Department of Energy
Office of Legacy Management

Subject: Transmittal of Modification to Rocky Flats Legacy Management Agreement (RFLMA) Attachment 1, Site Map and Attachment 2, Legacy Management Requirements, for approval

Proposed 2010 Modifications to Attachment 2—Legacy Management Requirements of the Rocky Flats Legacy Management Agreement (RFLMA)

Proposed 2010 Modifications to Attachment 2—Legacy Management Requirements of the Rocky Flats Legacy Management Agreement (RFLMA) Comment Responsiveness Summary

Figure 11. Groundwater Treatment Systems

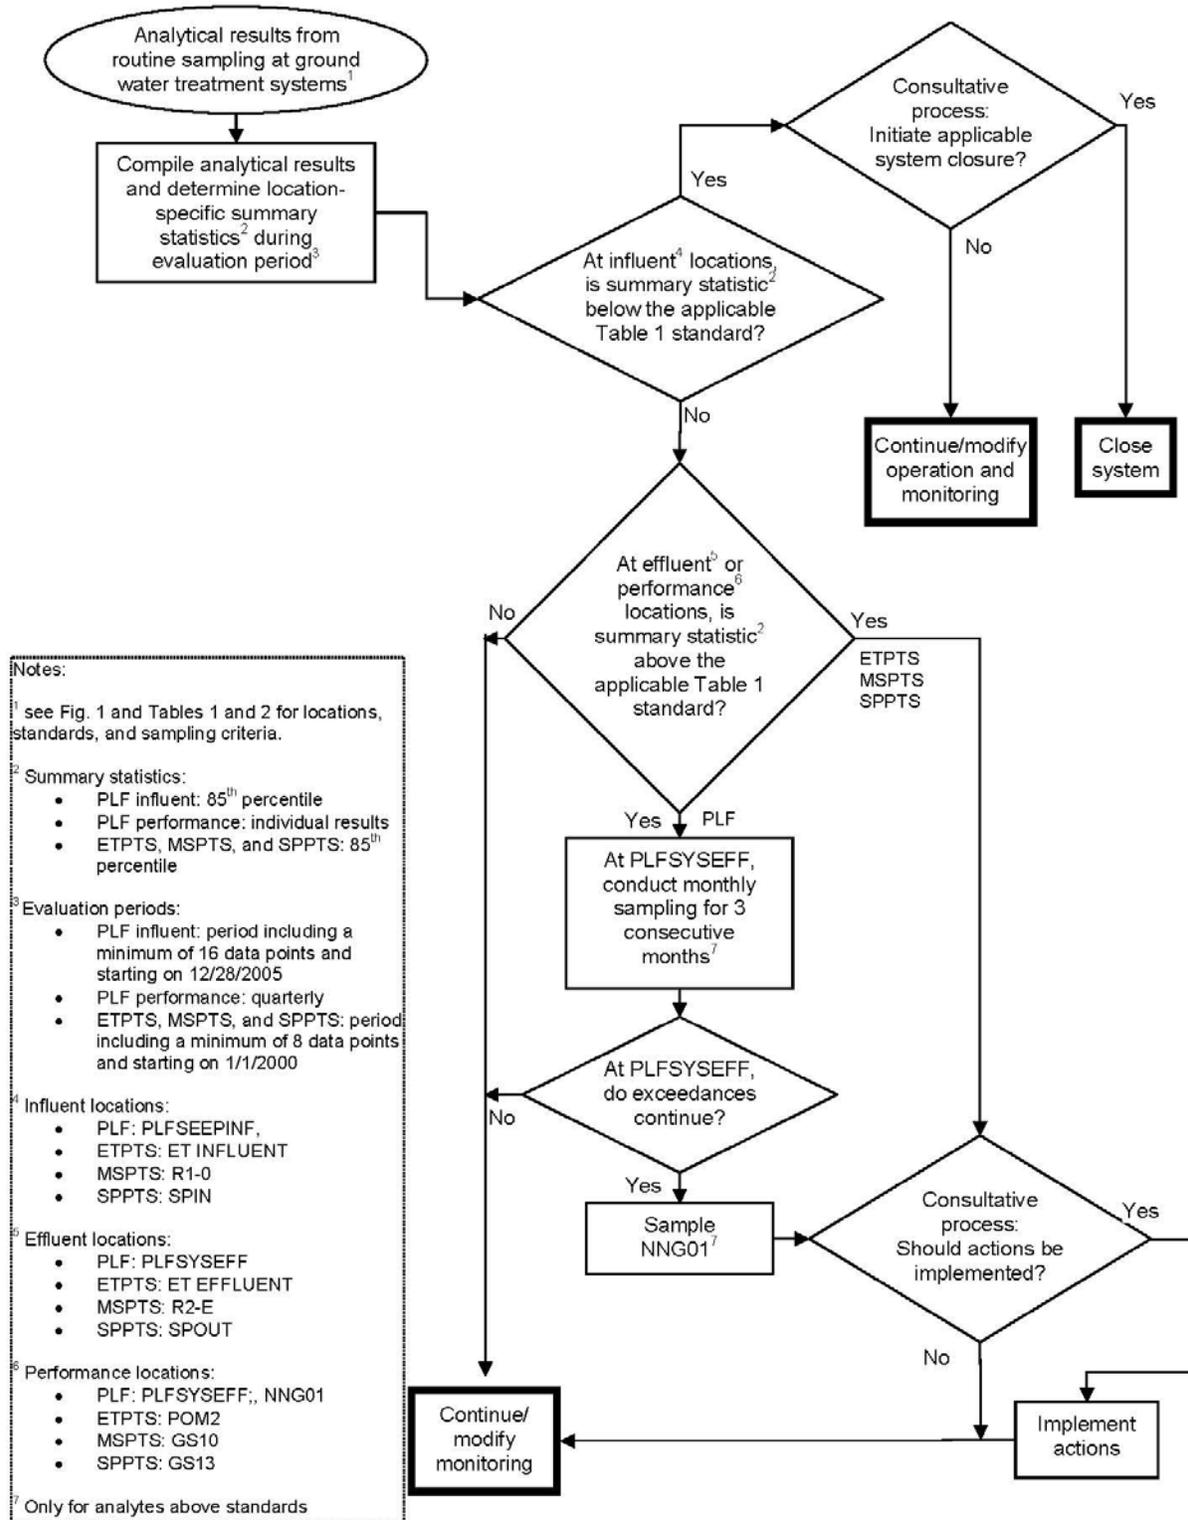
51	<p>Figure 11 Groundwater Treatment Systems - Page 36</p> <p>The following revisions should be made to the flow chart: Footnote 7 should be deleted based on the preceding item above.</p>	<p>See the response to Comment 50.</p> <p>The suggested change is not incorporated in the approved modification.</p>
52	<p>Figure 11 Groundwater Treatment Systems - Page 36</p> <p>The following revisions should be made to the flow chart: PLFPONDEFF should be deleted from footnote 6 if the monitoring site is removed.</p>	<p>The suggested change is incorporated in the approved modification.</p> <p>The RFLMA Parties also noted that the GWISINFNORTH and GWISINFSOUTH locations for the PLF influent in note 4 should have been deleted in the March 2008 modification consistent with changes to Table 2 at that time. The change is now incorporated in this modification.</p>

Figure 13. Pre-discharge Pond Sampling

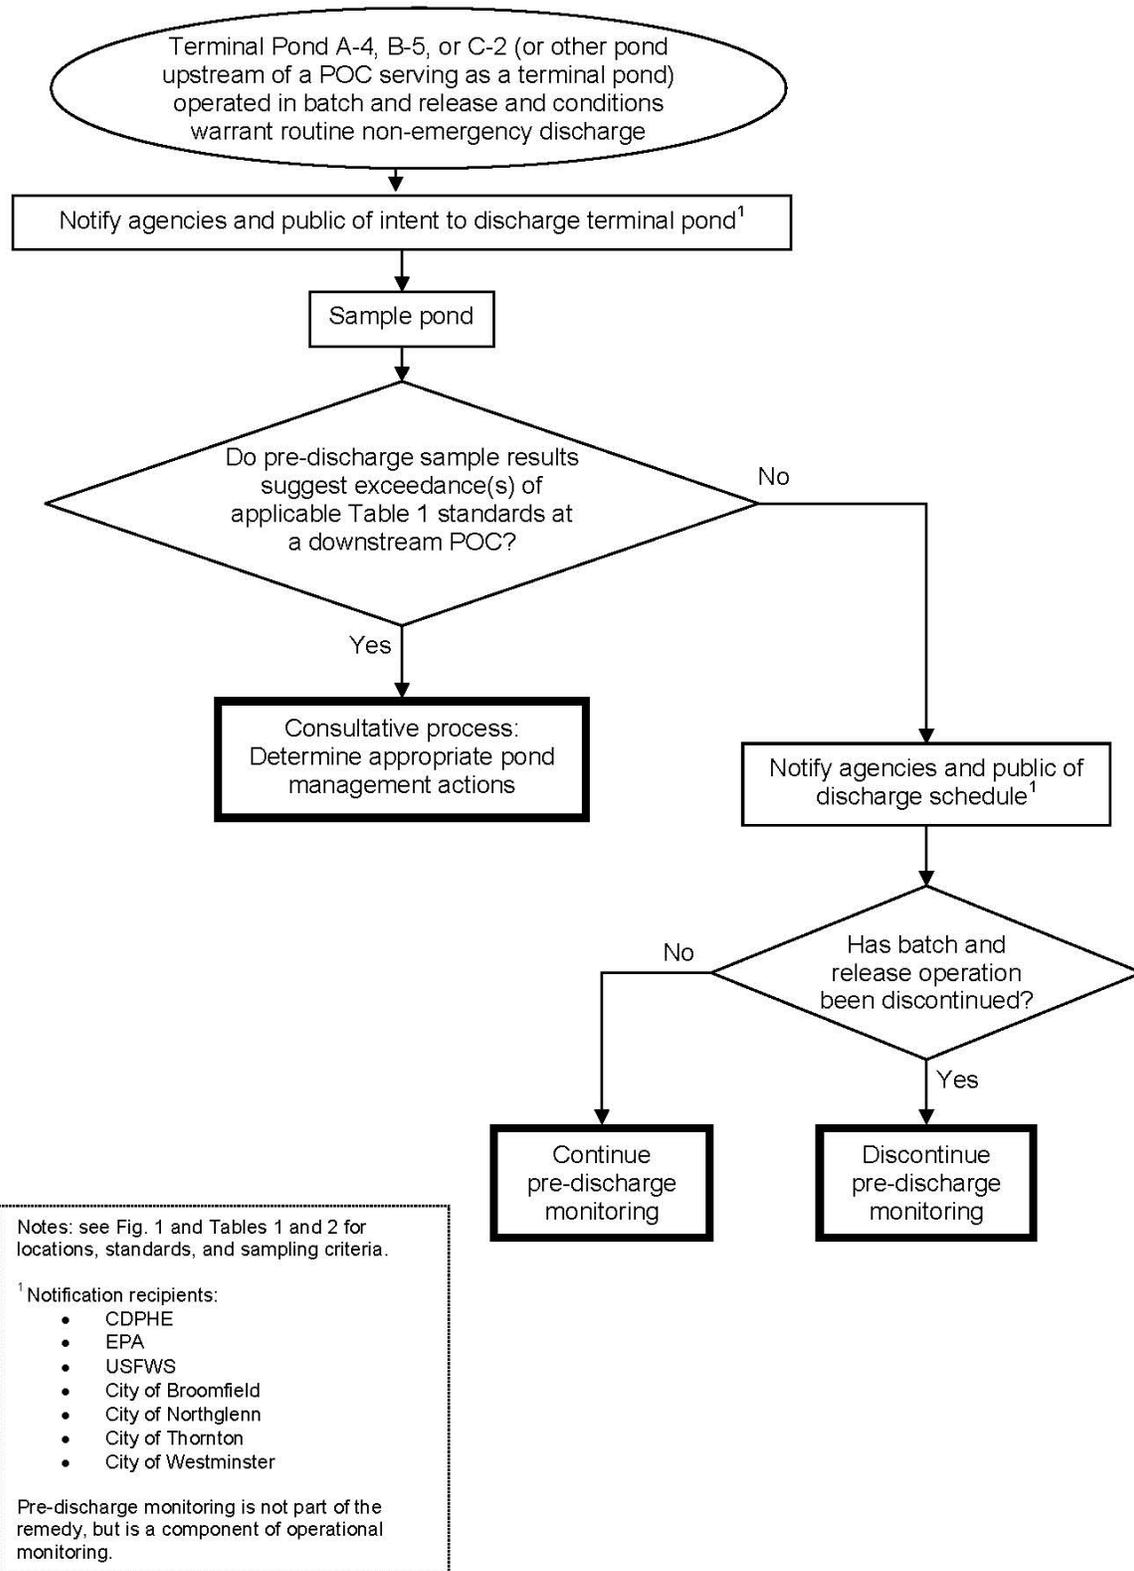
38	<p>Section 6.0 Action Determinations - Page 8</p> <p>The last bullet point that references Figure 13 Flowchart - Pre-discharge Pond Sampling should not be deleted.</p>	<p>See Common Concern Statement 8.</p> <p>See the response to Comment 35 concerning when batch-and-release operations cease.</p> <p>Figure 13 is retained, but provides a decision point to terminate pre-discharge sampling.</p>
39	<p>Table 1 Surface Water Standards - Pages 11 through 15</p> <p>Remove the Temporary Modifications column and delete footnotes [c] and [h].</p>	<p>The RFLMA Parties agree that the reference to the expired temporary modifications should be deleted, and the change is incorporated in the approved modification.</p>
40	<p>Table 1 Surface Water Standards - Pages 11 through 15</p> <p>Revise footnote [n] to indicate that the standard is for arsenic.</p>	<p>While footnote [n] is only in Table 1 for arsenic, the RFLMA Parties agree to add "arsenic" to the footnote and the change is incorporated in the approved modification.</p>

No.	Comment	DOE Response
53	Figure 13 Pre-discharge Pond Sampling - Page 38 This figure should not be deleted and be retained.	See Common Concern Statement 8. See the response to Comment 35 concerning flow-through operations, monitoring, and evaluation.
54	Broomfield is amenable to considering flow-through operations of the terminal ponds <u>contingent upon the development of operational and performance criteria for initiating or terminating flow-through operations on a temporary or permanent basis.</u> Such criteria must be agreed upon by the downstream communities and documented in RFLMA. In addition, DOE-LM must adopt a contingency plan that outlines the physical and/or operational actions that DOE-LM will employ in the event a compliance standard is exceeded at any surface water Point of Compliance.	See Common Concern Statements 5 and 8. See the response to Comment 35 concerning flow-through operations, monitoring, and evaluation. RFLMA does not dictate how ponds operate in batch-and-release or flow-through modes. For the Surface Water Configuration Environmental Assessment, DOE has initiated an Adaptive Management Plan development process with community participation that will serve to address this comment.

Although the proposal included elimination of predischarge sampling, the sampling and evaluation protocol has been retained in the final modifications. Predischarge samples will continue to be collected as long as the ponds are operated in batch and release mode. RFLMA and the CAD/ROD are subject to Resource Conservation and Recovery (RCRA) and CERCLA regulatory authorities, which are separate from the NEPA evaluation to breach the dams. The
